T-049 SERVICE BULLETIN

Rework of E6878426 2nd Stage Nozzle for C20B Installation

Engine Application(s):	Allison 250-C20B
Subject:	Rework procedures for E6878426 2 nd Stage Nozzle Assy to allow for installation in 250-C20B and B17B model engines.
Compliance:	Customer option.
Revisions:	N/C Dated: 6/10/99 Original issue. A Dated: 9/03/09 Updated EXTEX to TIMKEN. B Dated: 2/04/16 Updated TIMKEN to EXTEX Engineered Products.

FIGURE 1

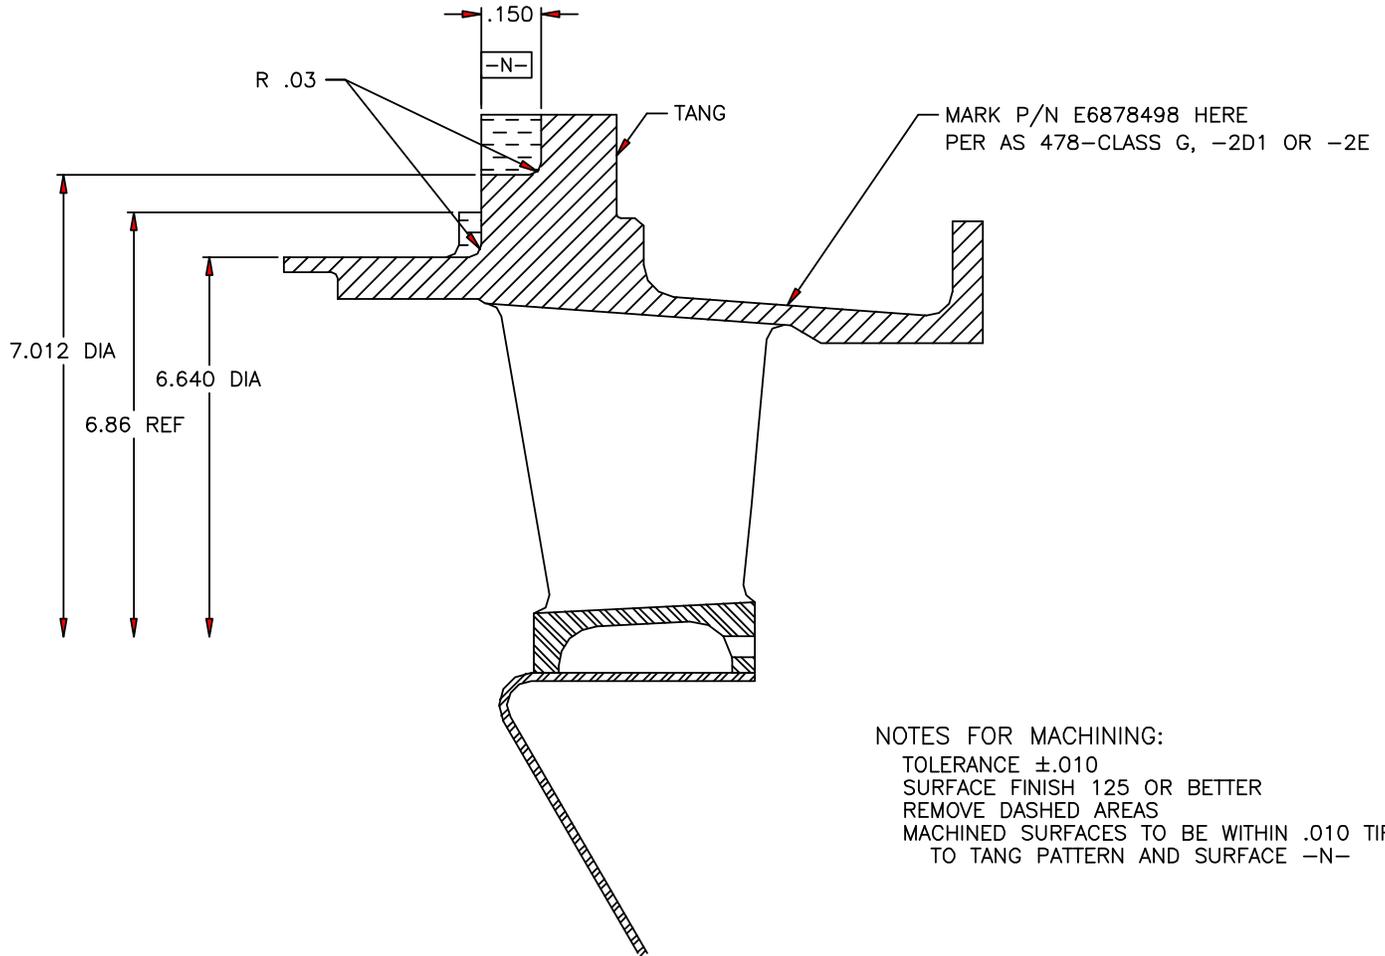
To modify the OD of 2nd stage turbine nozzles to allow installation in 250-C20B and 250-B17B engines.

1. Machining or grinding a balance air annulus in the nozzle OD.
2. Machining or grinding to remove the relief between the wheel shroud and tang.
3. Re-identification requirements.

1. Rework Nozzle Assembly, P/N E6878426.
 - 1.1 No inspection is required when performing this work on a new nozzle.
 - 1.2 Machine or grind per Figure 1.
 - 1.3 Obliterate old P/N E6878426 and re-identify as E6878498.
